Project	IEEE 802.16 Broadband Wireless Access Working Group < <a href="http://ieee802.org/16">http://ieee802.org/16</a> >	
Title	Extension of collaborative spatial multiplexing in OFDMA	
Date Submitted	2004-11-16	
Source(s)	Bin-Chul Ihm, Yongseok Jin, Jinyoung Chun, Kyuhyuk Chung	Voice: 82-31-450-7187 Fax: 82-31-450-7912
	LG Electronics, Inc. 533, Hogue-1dong, Dongan-gu, Anyang-shi, Kyongki-do, Korea	[mailto: {bcihm, jayjay, jychun03, kyuhuk} @lge.com]
	Ran Yaniv, Tal Kaitz	[mailto: {ran.yaniv, tal.kaitz} @alvarion.com]
	Alvarion Ltd.	
Re:	This is a response to a Call for Comments on IEEE P802.16e-D5	
Abstract	The collaborative spatial multiplexing can be applied to the case in OFDMA.	
Purpose	This document is submitted for review by 802.16e Working Group members. <b>Green line indicates the revised text and we revise and add simulation results because we got the comments.</b>	
Notice	This document has been prepared to assist IEEE 802.16. It is offered as a basis for discussion and is not binding on the contributing individual(s) or organization(s). The material in this document is subject to change in form and content after further study. The contributor(s) reserve(s) the right to

Figure yyy – MIMO tile in UL PUSC mode

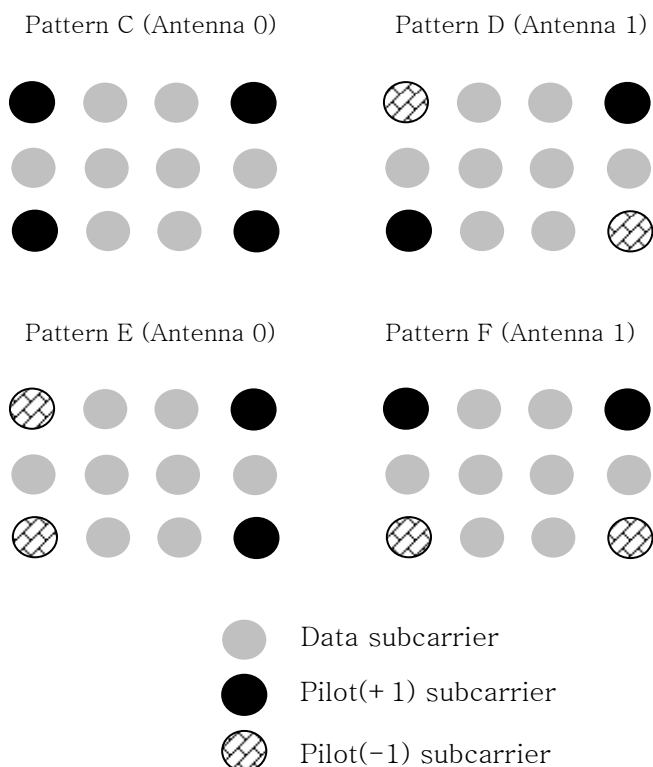
*[Add a new section 8.4.8.1.5.1]*

#### 8.4.8.1.5.1 Uplink using enhanced STC

A user supporting transmission using STC configuration in the uplink, shall use a modified uplink tile, 2-transmit diversity data or 2-transmit spatial multiplexing data can be mapped onto each subcarrier, the mandatory tile shall be modified to accommodate those configurations. Figure yyy depicts the UL tiles for enhanced STC transmission in PUSC mode.

Two SS's of one or two transmission antenna can perform collaborative spatial multiplexing onto the same subchannel. In this case, each SS should use the uplink tile with the pilot pattern indicated in MIMO\_UL\_Enhanced\_IE. A dual transmit antenna SS can use the allocation in STTD, SM or collaborative SM mode with other SS. SS in collaborative SM mode with dual transmit antenna sends data in ordinary STC configurations as in section 8.4.8.1.4 using the pilot pattern pair indicated in MIMO\_UL\_Enhanced\_IE. The first pilot pattern in each pair is for antenna 0 and the second is for antenna 1.
